BOARD OF DIRECTORS MINUTES

BOARD OF DIRECTORS' MINUTES | SPORTS CAR CLUB OF AMERICA, INC. | Feb. 6-10, 2008

CRB Conference Call – January 7, 2008

Fig 1

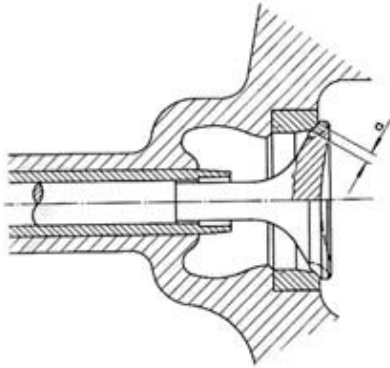
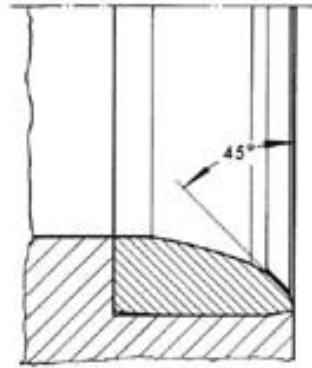
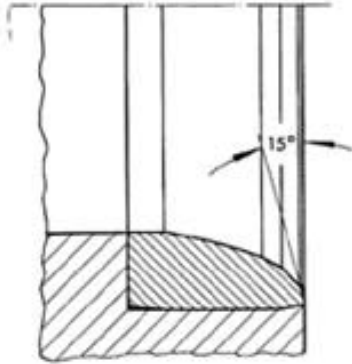
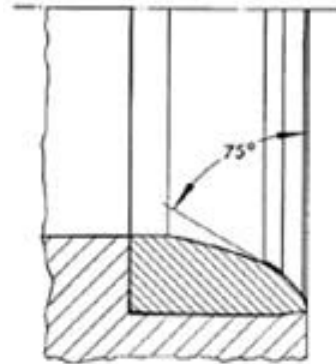
5.6.5. Valves and valve seats may not be reshaped. Valve to valve seat mating surface (figure 1) shall be cut as follows. The 45 deg valve seat width (figure 2) shall be maintained by cutting a 15 deg chamfer (figure 3) at the outside edge of the seat and a 75 deg chamfer (figure 4) at its inner edge. Seats cannot be refaced if too little material remains for a 15 deg chamfer to be cut without going beyond the boundary of the insert. If the chamfer extends to the head, the seat or the head must be replaced.

5.6.5.1. Valve specifications (figures 1 & 5):

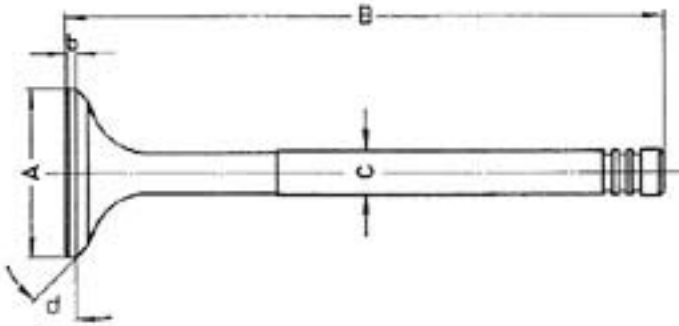
Dimension "a" – valve seat contact width: Intake – 1.30 mm to 1.60 mm
 Exhaust – 1.70 mm to 2.00 mm Seat contact angle on valve: 45 deg Intake and Exhaust
 Dimension "A" – valve head dia: Intake – 35.56 mm max. Exhaust – 32.06 mm
 Dimension "B" – valve length: 110.5 mm to 112.5 mm
 Dimension "C" – valve stem dia: Intake – 7.94 mm min. Exhaust – 7.91 mm
 Dimension "b" – valve head margin: Intake – .80 to 1.50 mm Exhaust – 1.00 to 1.70 mm
 Dimension "d" – face angle of valve only: Intake - 44 deg Exhaust - 45 deg

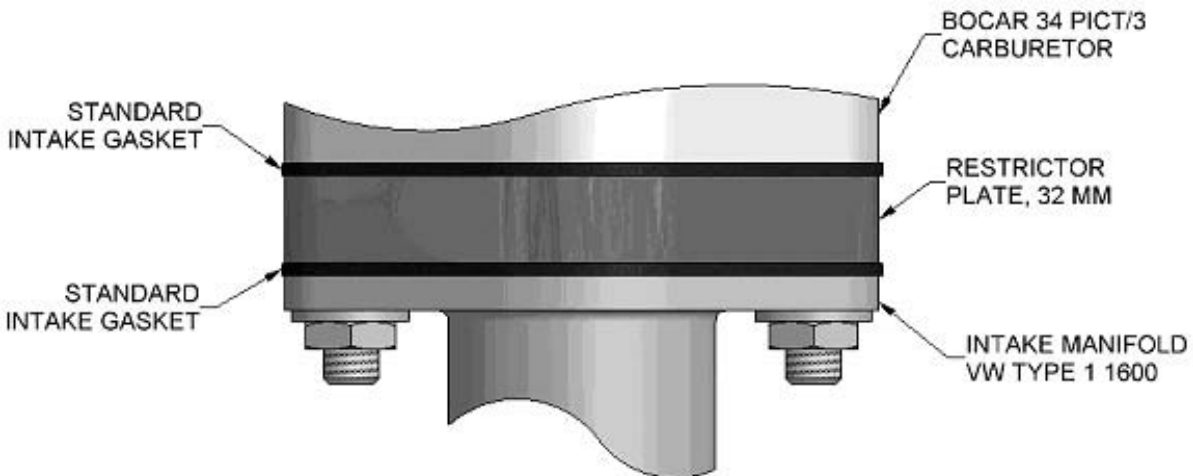
5.10.5. Port matching to a depth of 1.0" into the manifold casting from the manifold/head joining surface is permitted.

5.10.6. The official Formula First 32 mm restrictor plate must be installed per the following instructions listed. Absolutely no modifications are permitted to the restrictor plate. Any defects or marks on the blue anodize is not allowed and must be exchanged immediately for a new official Formula First 32 mm restrictor plate.
